# Error reporting

Tracker Week 01/2003

FE\_HYBRID TO UTRI ADAPTER CARD

EDMS REF:318639	VERSION:4	PCB:EP 680-1174-400-C SYSTEM:	
REF: EP 680-1174-400-C	TITLE: FE_HYBRID TO UTRI / TEST ADAPTER CARD		
 IT/CE	DIV. EP	ABBREU:	PAGE: 1/1
	1211 GENEVA 23	LAST_MODIFIED=Mon Sep 23 15:06:59 2002	
	SWITZERLAND	DESSIN: SANCHEZ M.	ETUDE: HAMMARSTROM DATE: 03/07/00

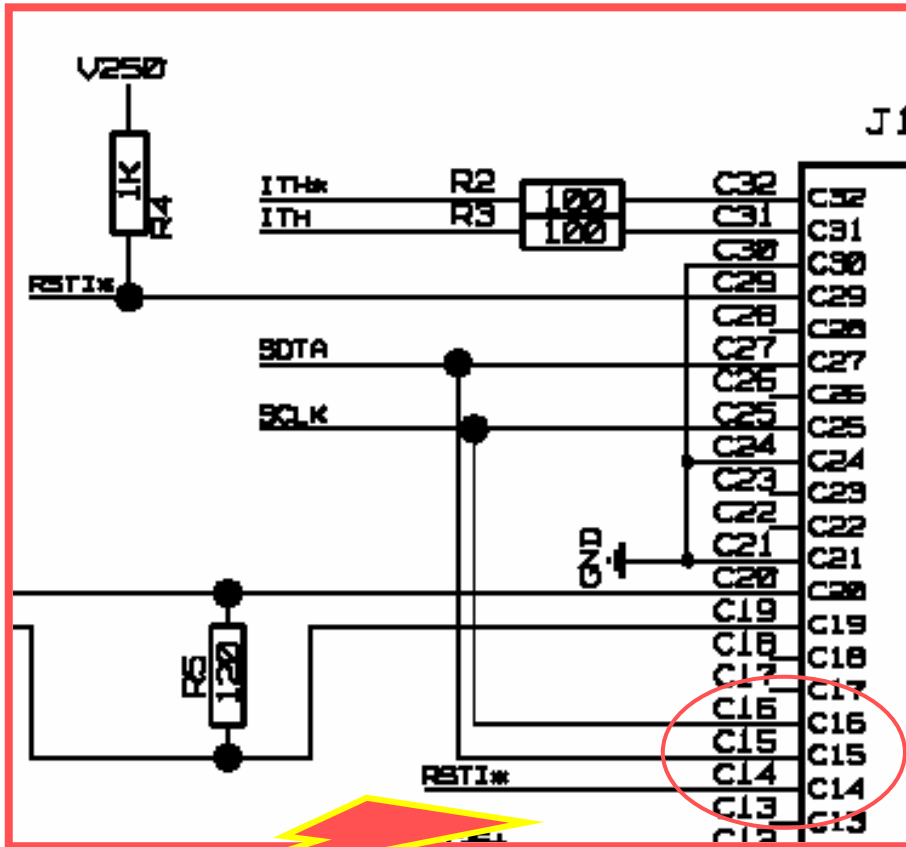
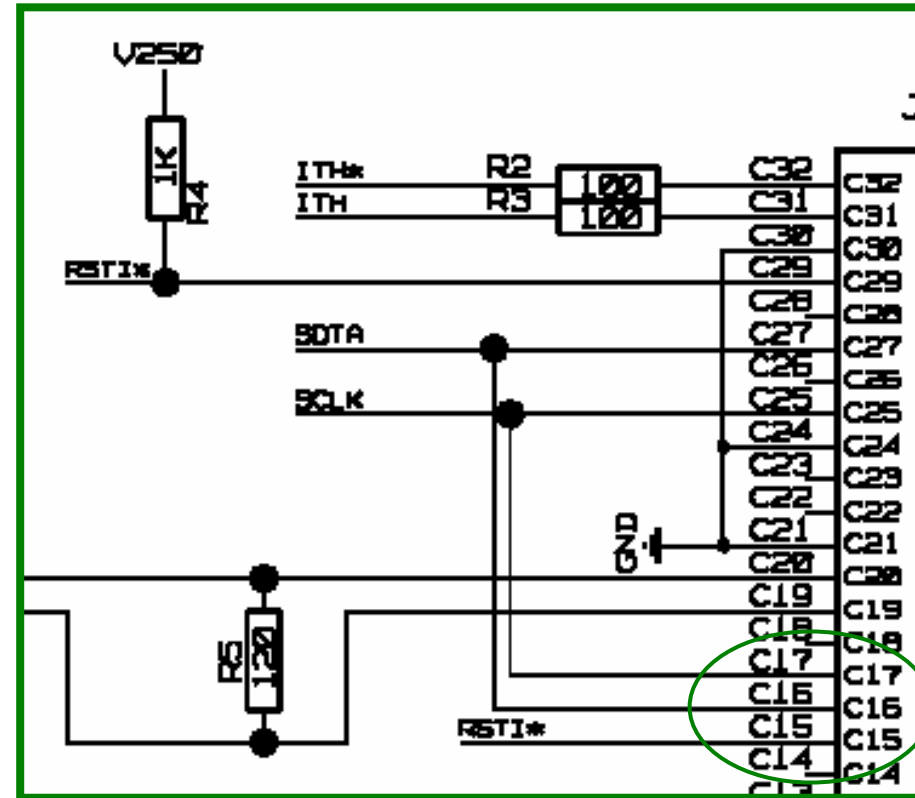
Bad because C14 is connected to V250 (in VUTRI)

➔ No (reliable) reset.

C15 and C16 connected to OHRST & OHSDA

➔ No problem if no opto-hybrid
